**ADDENDUM #2
ADAMS COUNTY
CASTLE ROCK PARK MAINTENANCE BUILDING
PROJECT 05056005
OCTOBER 31, 2025**

REPLACE Sheets A101, E200 and H100 in their entirety with the attached marked "Addendum No. 2".

SHEET
A101

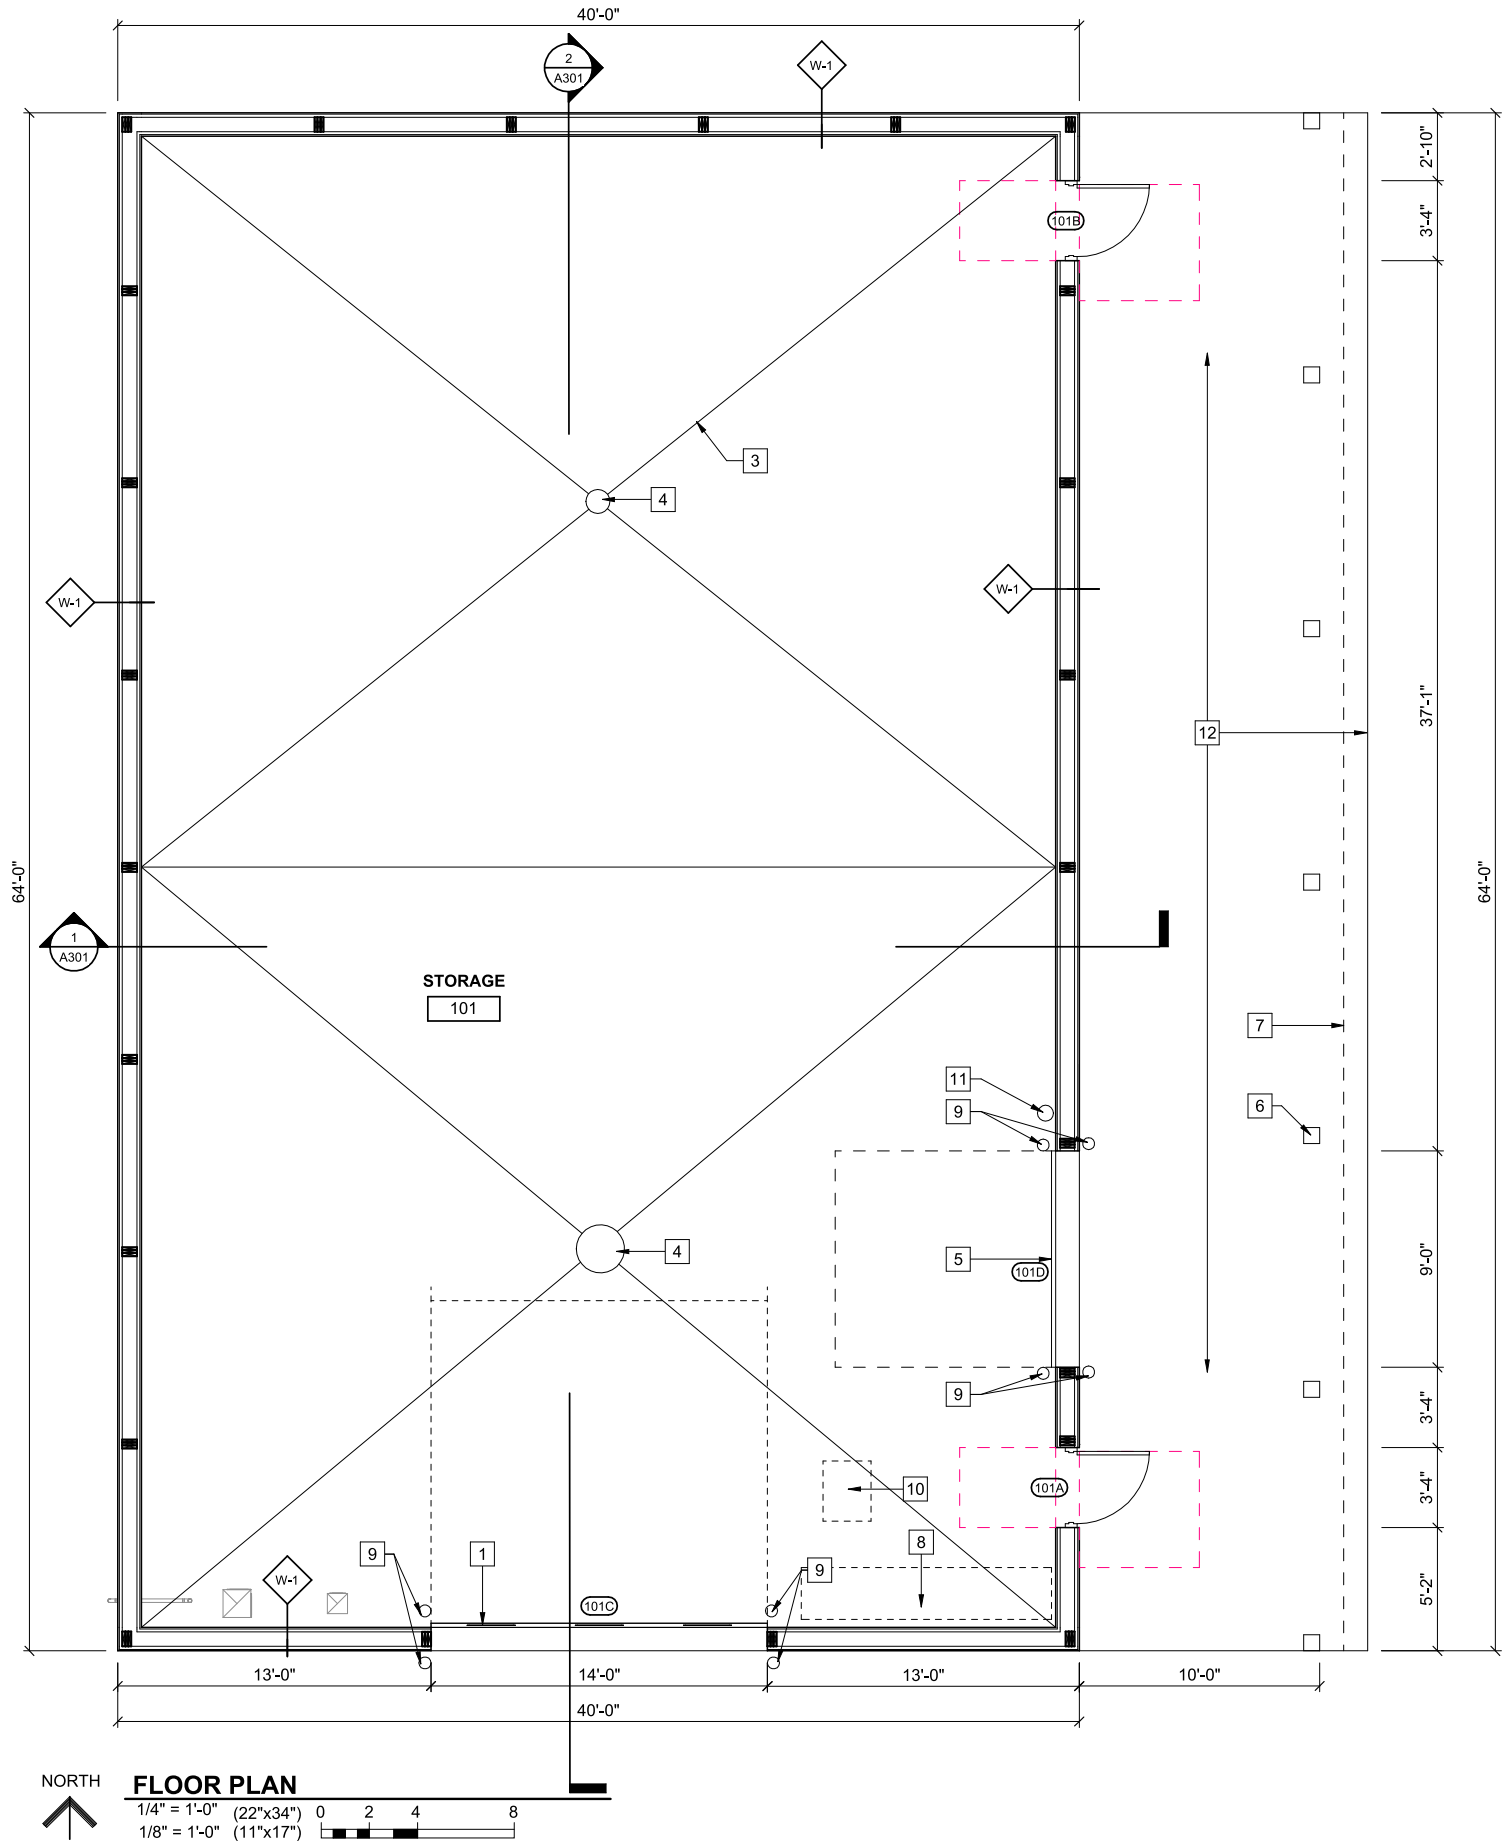
- Added Thermal Performance/Energy Code Compliance Notes.
- Revised electrical panel schedule and diagram.
- Revised location of the duct furnace and intake air.

PRESCRIPTIVE ENERGY CODE COMPLIANCE

COUNTY OF PROJECT: ADAMS		CLIMATE ZONE: 6A	
ASSEMBLY	MIN CODE REQUIRED	DESIGN	DOES DESIGN EXCEED REQUIRED?
ROOF, ATTIC ²	R-38	R-53	YES
WALLS, WOOD-FRAMED 8IN o.c ²	U-0.051	U-0.05	YES
SLAB -ON-GRADE FLOOR, UNHEATED SLAB ¹	R-10 FOR 24" BELOW	R-15	YES
DOOR: INSULATED, NON-METAL EDGE (OVERHEAD DOOR) ³	U-0.35	U-0.35	YES
DOOR: INSULATED METAL (HOLLOW METAL DOOR) ³	U-0.6	U-0.6	YES
